NOTICE OF DATA INACCURACY

Pursuant to Government Code section 15472, et seq, the Office of Energy Infrastructure Safety (Energy Safety) has conducted an inspection of work completed by PacifiCorp (PC) in accordance with its 2025 Wildfire Mitigation Plan (WMP) and determined the existence of inaccurate data. Energy Safety therefore issues PC a Notice of Data Inaccuracy (NODI).

From May 19, 2026, to May 21, 2026, Energy Safety inspected 2025 Q4 WMP initiatives in the vicinity of Etna, Fort Jones, and Yreka. Energy Safety found the following data inaccuracies: Data Inaccuracies 1-3: 8.1.2.1 Covered Conductor installation, the inspector observed that PC failed to adhere to data accuracy. No covered conductor was observed by the inspector at the submitted segments. Data Inaccuracies 4-11: 8.1.2.3 Distribution pole replacement and reinforcements, the inspector observed that PC failed to adhere to data accuracy. Two distribution pole replacement initiatives have been submitted at these locations. Data inaccuracy 12: 8.1.2.12 Expulsion Fuse Replacements, the inspector observed that PC failed to adhere to data accuracy. Two expulsion fuse replacement initiatives have been submitted at thi

Data Inaccuracy 4

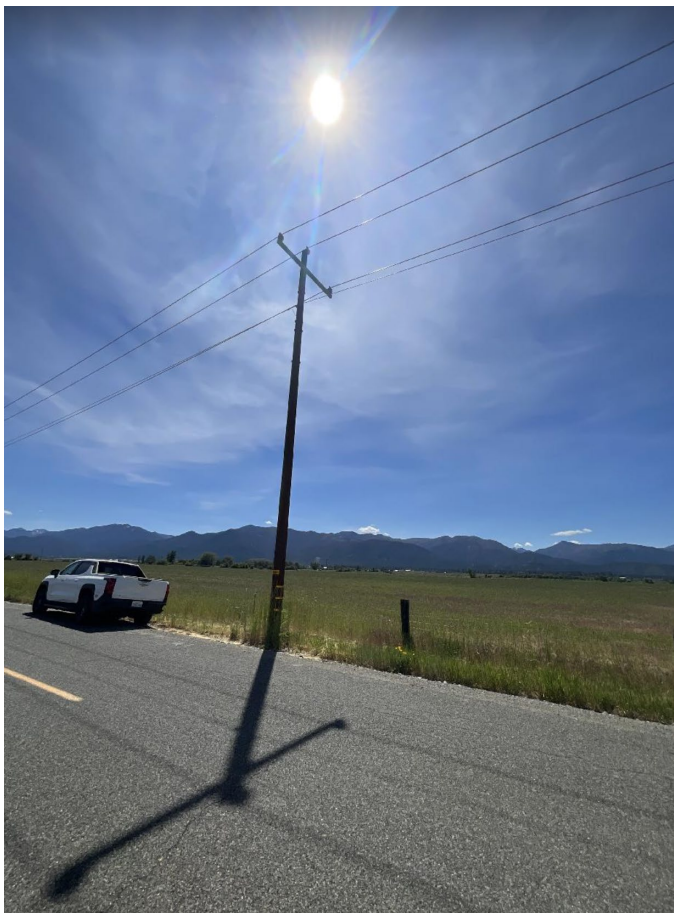
Data Inaccuracy Img4-1: Overall structure showing one pole, despite two distribution replacement initiatives that have been submitted at this location for the same quarter (Q4).
